Subject: Submittal Supporting Accelerated ABWR Review Schedule - **DFSER Open**
Item 1.2.6-1

Enclosed is a SSAR markup addressing DFSER Open Item 1.2.6-1.

ABWR Standard Plant

OPEN 1.2.6-1

FIGURE 1.2-1 SITE PLAN

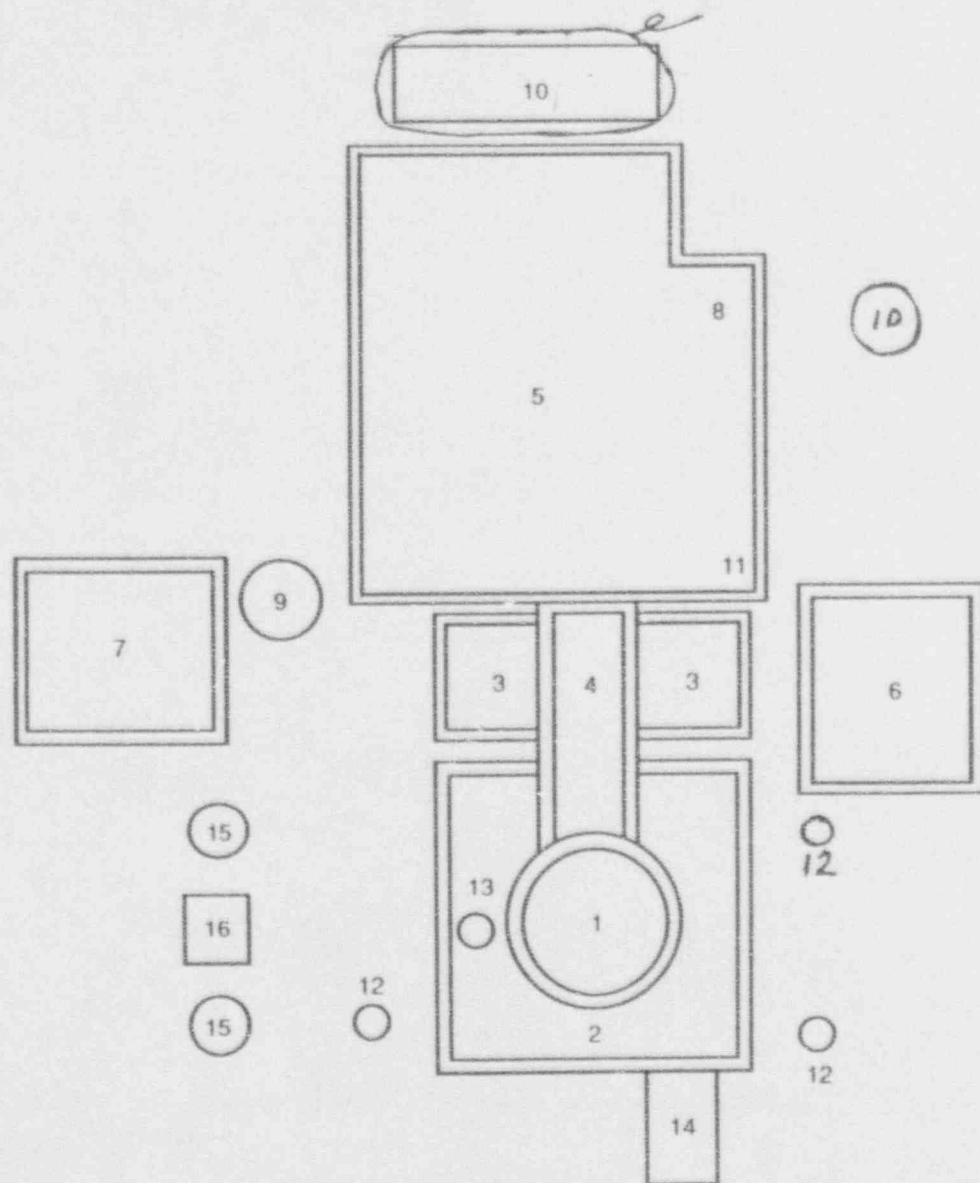
In addition to these buildings and their contents, the ABWR Standard Plant provides the supporting facilities shown in Figure 1.2-1.

The ABWR evolutionary design provides an essentially complete nuclear power plant except for site-specific elements. The site-specific elements are included as representative conceptual designs with interface requirements sufficient for the final safety analysis and design-specific probabilistic risk assessment in accordance with 10 CFR ~~52.47~~ 52.47(a)(1)(vii) and (b)(1). These are:

- (1) Ultimate heat sink
- (2) Offsite power (transmission)
- (3) Make up water (preparation)
- (4) Potable and sanitary water
- (5) Reactor service water
- (6) Turbine service water
- (7) Lighting and servicing power supply
- (8) Communications
- (9) Site security
